SUBJECT: JOSEPH M. FARLEY NUCLEAR PLANT, UNITS 1 AND 2 - STAFF
ASSESSMENT OF INFORMATION PROVIDED PURSUANT TO TITLE 10 OF
THE *CODE OF FEDERAL REGULATIONS* PART 50, SECTION 50.54(f),
SEISMIC HAZARD REEVALUATIONS FOR RECOMMENDATION 2.1 OF THE
NEAR-TERM TASK FORCE REVIEW OF INSIGHTS FROM THE FUKUSHIMA
DAI-ICHI ACCIDENT (TAC NOS. MF3832 AND MF3833)

STAFF ASSESSMENT BY THE OFFICE OF NUCLEAR REACTOR REGULATION

RELATED TO SEISMIC HAZARD AND SCREENING REPORT

JOSEPH M. FARLEY NUCLEAR PLANT, UNITS 1 AND 2

Figure 3.3-1 Plot of Staff's and Licensee's Base Case Shear-Wave Velocity Profiles for the Farley Site

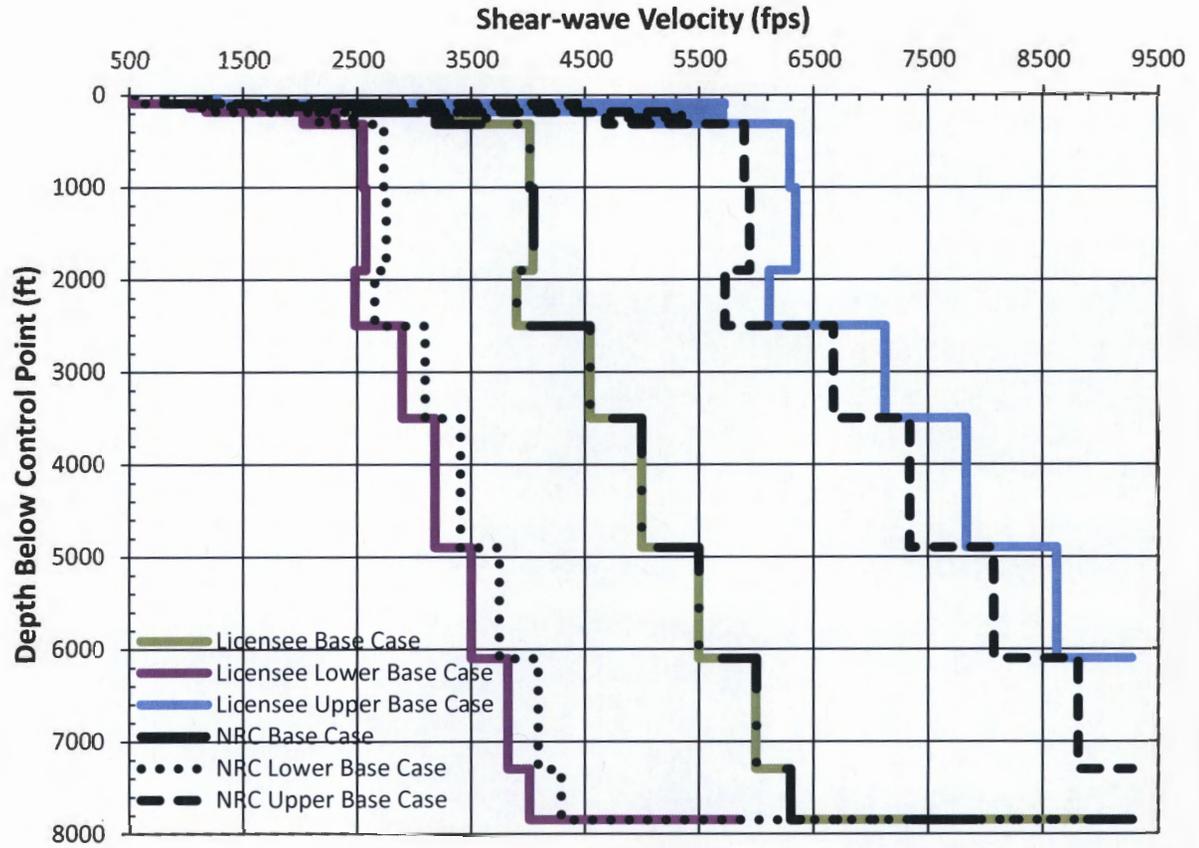
Based on the amount and quality of information provided in the Farley UFSAR, the NRC staff adopted the base case site profile used by the licensee. Given the availability of data at the site, the NRC staff used a natural log standard deviation of 0.3 to calculate upper and lower base case velocity profile. This standard deviation is slightly lower than that used by the licensee (0.35) and is based on the staff's interpretation of the uncertainty in the properties of the subsurface soil and rock layers. Figure 3.3-1 of this assessment shows a comparison of base case profiles developed by the licensee with those developed by the NRC staff. To capture the uncertainty in the depth to base rock beneath the site, the NRC staff randomized the depth to base rock by ± 10 percent, approximately 785 ft. (239 m). In addition, the NRC staff adopted the shear modulus degradation and damping curves used by the licensee because these curves are based on direct measurement of at site materials.

Figure 3.3- 1 Plot Comparing the Staff's and the Licensee's Median Amplification Functions and Uncertainties for the Farley Site.

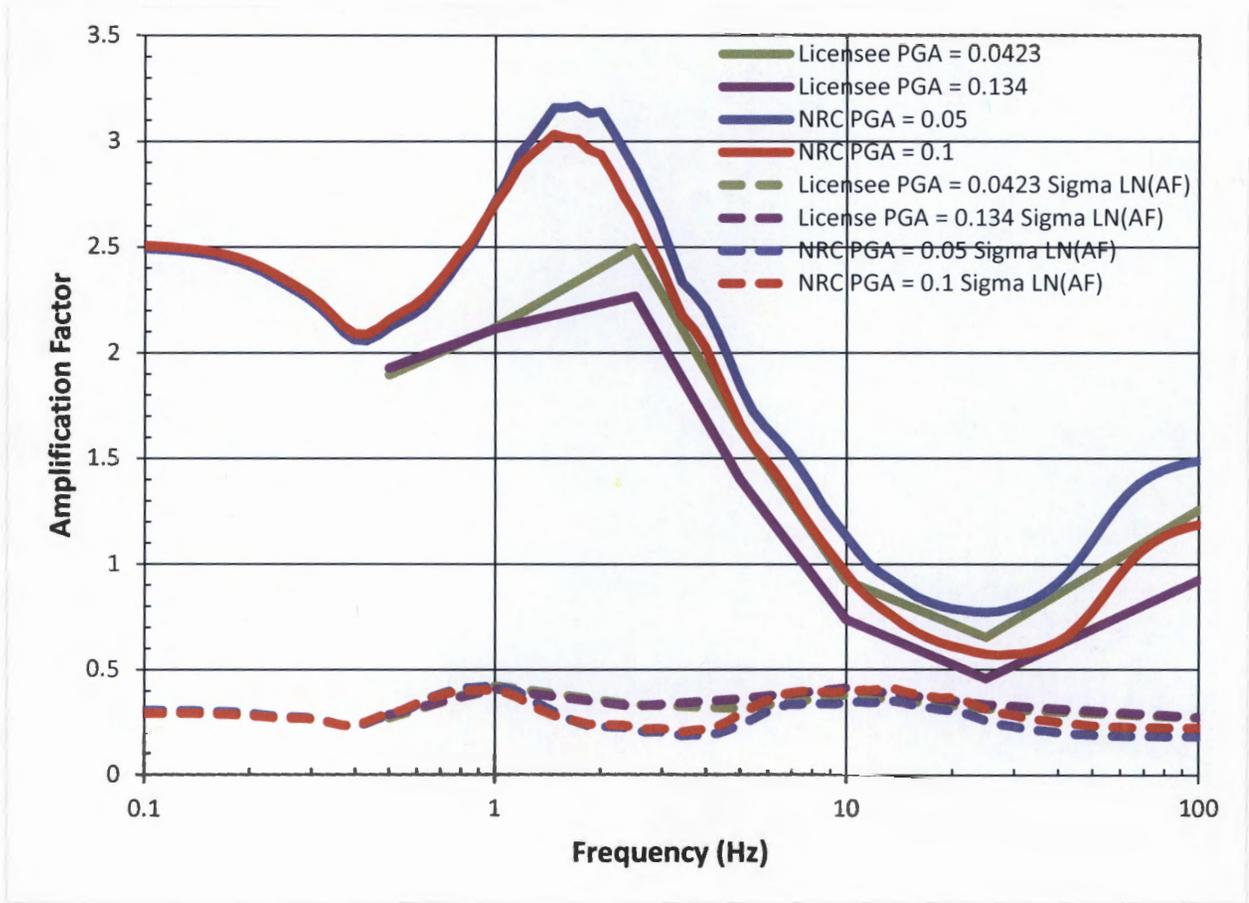
Figure 3.3-2 of this assessment shows a comparison of the staff's and the licensee's median site amplification functions and uncertainties (± 1 standard deviation) for two of the eleven input loading levels. The staff's and licensee's amplification functions are generally similar in shape to the licensee's but are systematically higher due to differences in developing site profiles, as discussed above. As shown in Figure 3.3-3 of this assessment, these differences in site response analysis have a moderate impact on the control point seismic hazard curves, and the resulting GMRS, as discussed below. Appendix B of the SPID provides guidance for performing site response analyses, including capturing the uncertainty for sites with less subsurface data; however, the guidance is neither prescriptive nor comprehensive. As such, various approaches in performing site response analyses, including the modeling of uncertainty are acceptable for this application.

Figure 3.3-2 Plot Comparing the Staff's and the Licensee's Mean Control Point Hazard Curves at a Variety of Frequencies for the Farley Site

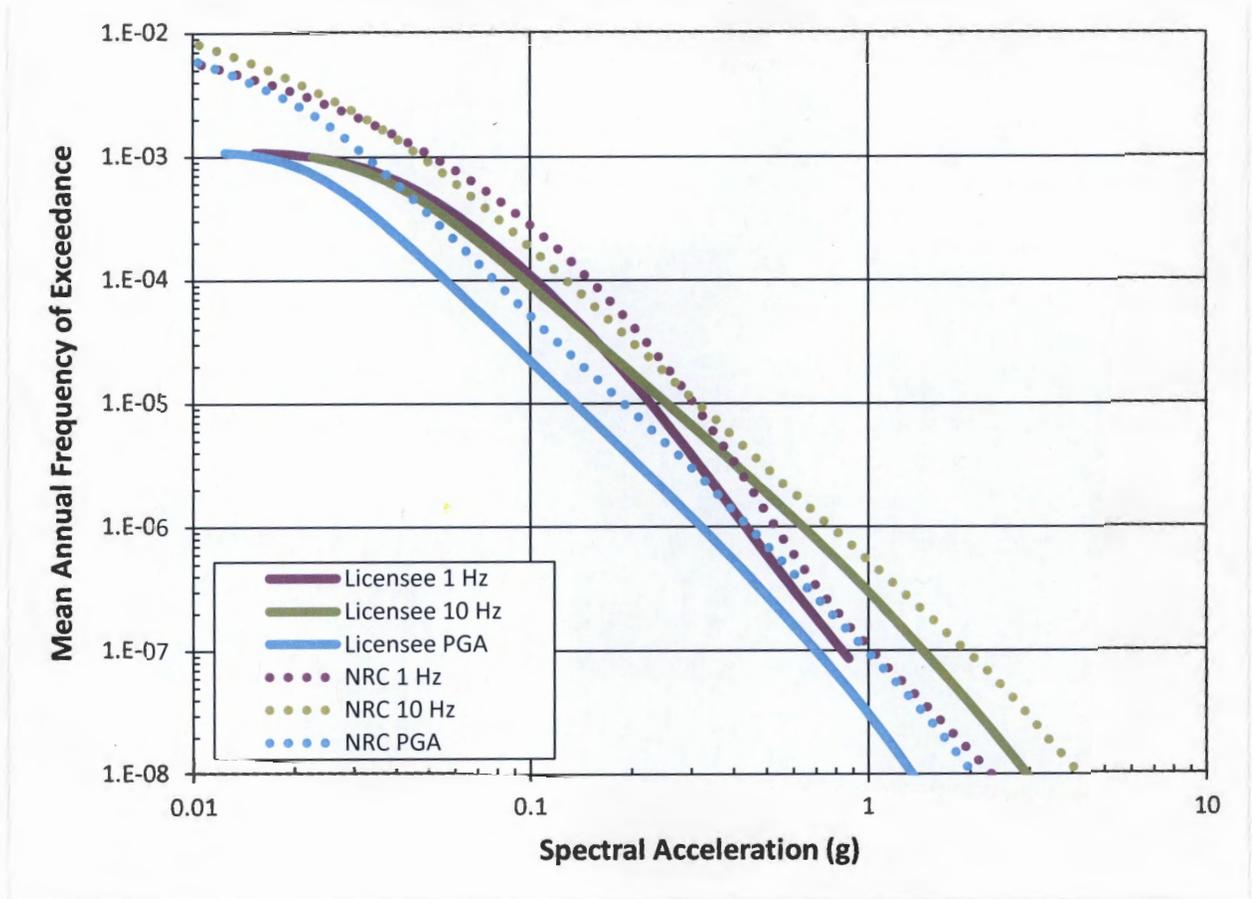
In summary, the NRC staff concludes that the licensee's site response was conducted using present-day guidance and methodology, including the NRC-endorsed SPID. The NRC staff performed independent calculations which confirmed that the licensee's amplification factors and control point hazard curves adequately characterize the site response, including the uncertainty associated with the subsurface material properties, for the Farley site.
